ENGINE—6.8L—OIL LEVEL INDICATOR READS INACCURATE—SUPER DUTY F-53 MOTORHOME CHASSIS VEHICLES—UPDATED OIL LEVEL INDICATOR

**Article No.
01-10-5**

FORD: 1999-2001 SUPER DUTY F-53 STRIPPED CHAS.

Figure 1 - Article 01-10-5

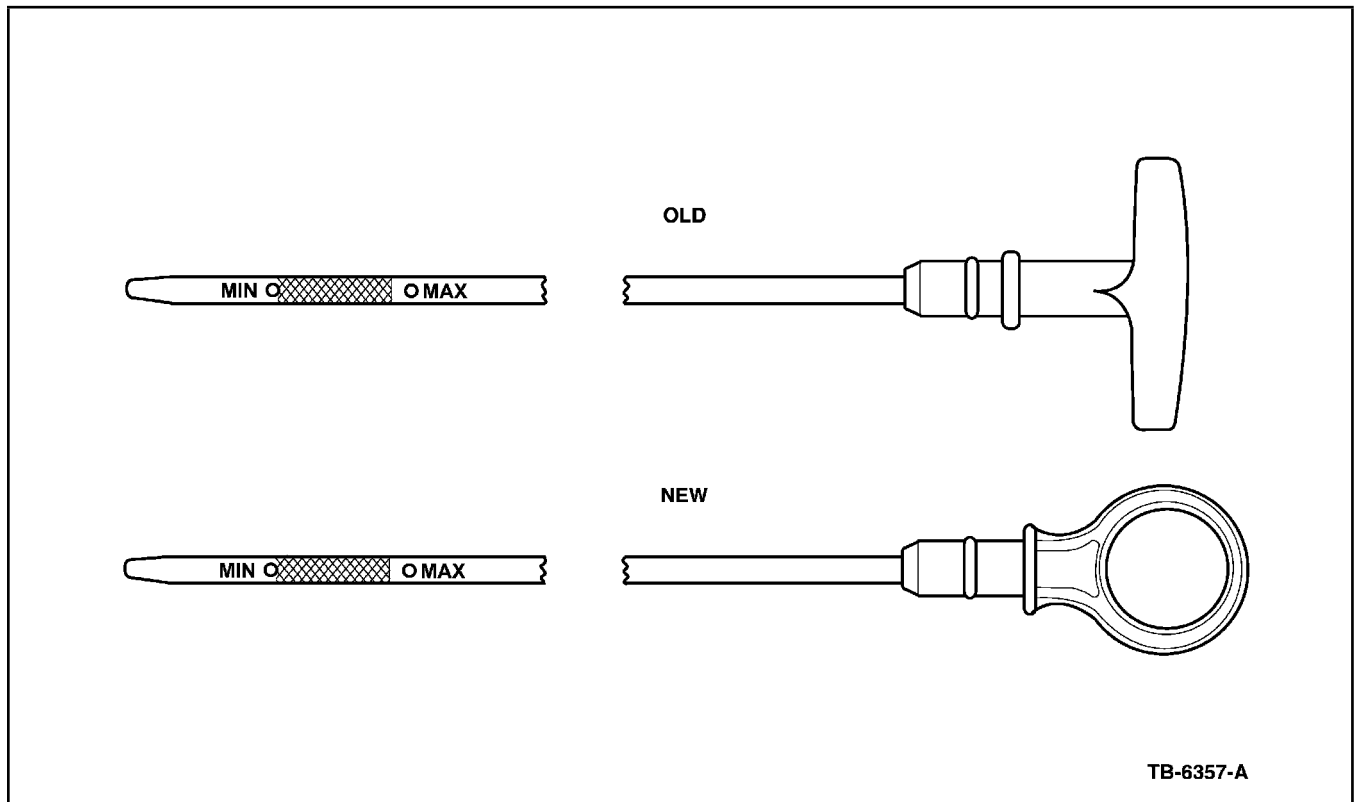
On some 6.8L equipped Super Duty F-53 Motorhome chassis vehicles, the oil level readings on the engine oil level indicator (dipstick) may read inaccurate (low) when the actual levels are within acceptable limits and adequate oil volume is in the sump. This may be noticed after an oil change, 5.7 L (6 quarts) of oil are added, and the engine has been started to fill the galleys and filter. The engine oil level indicator may then indicate 0.47 to 0.95 L (1/2 to 1 quart) low. This may be caused by the oil level indicator design.

(F81Z-6750-HC) which has correct markings to record oil levels at acceptable ranges. The new indicator has a "loop" handle. The prior indicator has a "Tee" stick-type handle (Figure 1).

Remove engine oil level indicator and replace with new design engine Oil Level Indicator
